MECHANICAL PLAN SCALE: 1/8"=1'-0" NORTH

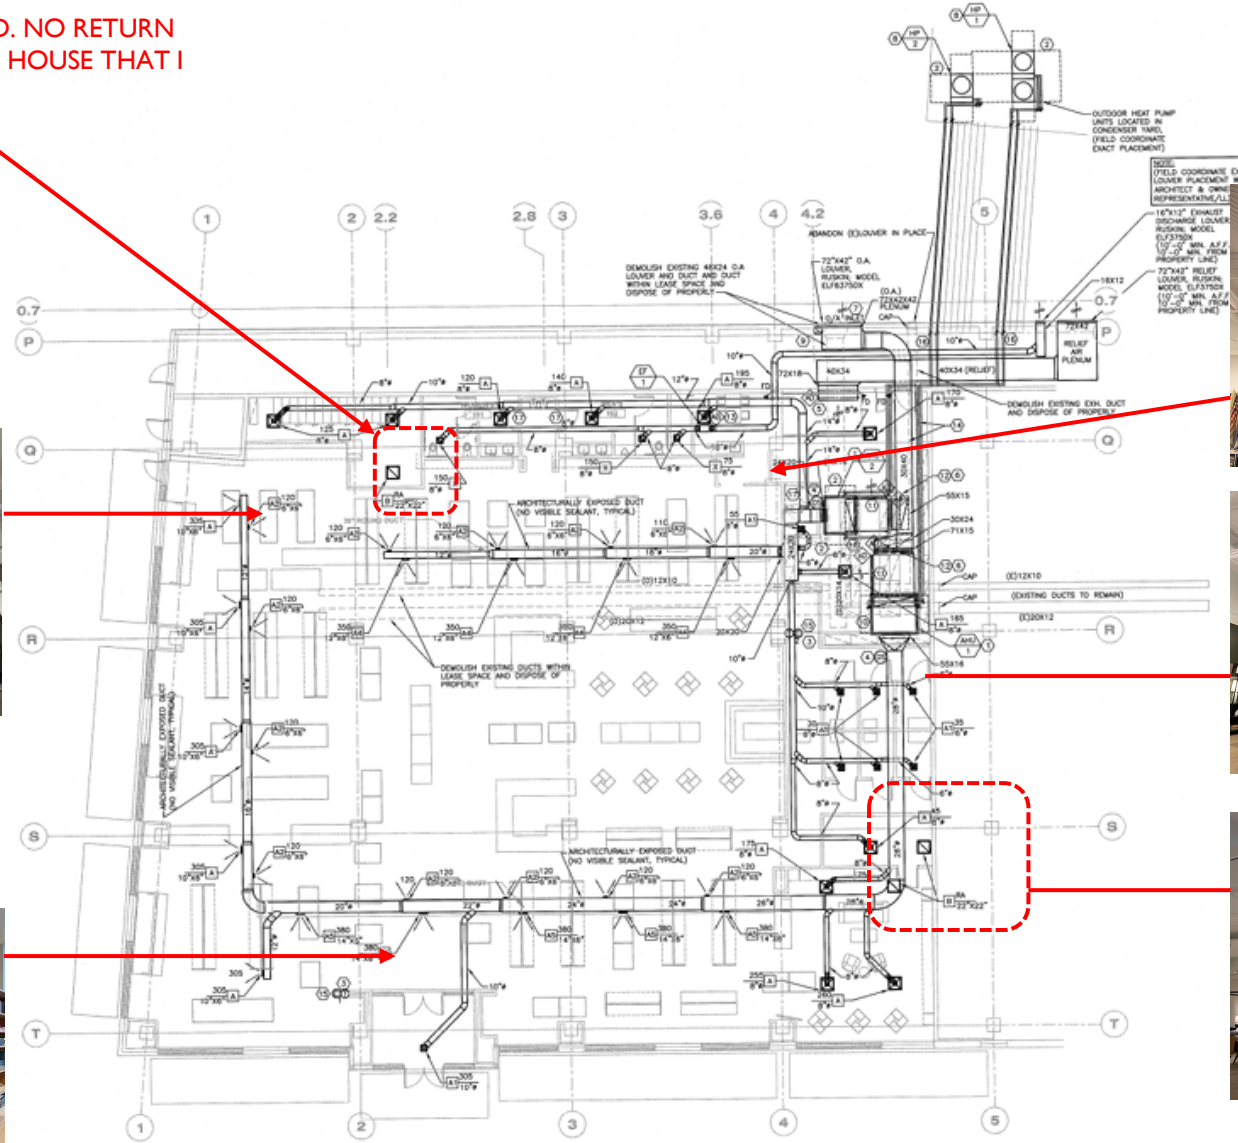
RETURN AIR REMOVED. NO RETURN AIR IN THE FRONT OF HOUSE THAT I COULD SEE

ONE THERMOSTAT POSITIVE AIR IN FRONT OF HOUSE,

DUCTLESS VENTS ABOVE BACK OF HOUSE DOOR. DOOR NEEDS TO REMAIN OPEN OTHERWISE SHOWROOM IS POSITIVE AND CREATES LOUD WISTLE AT FRONT DOOR. ALSO, NEGATIVE IN BACK OF HOUSE

VERY LOUD UNIT WITH STRONG AIR FLOW

RETURN AIR REMOVED. NO RETURN AIR IN THE FRONT OF HOUSE THAT I COULD SEE
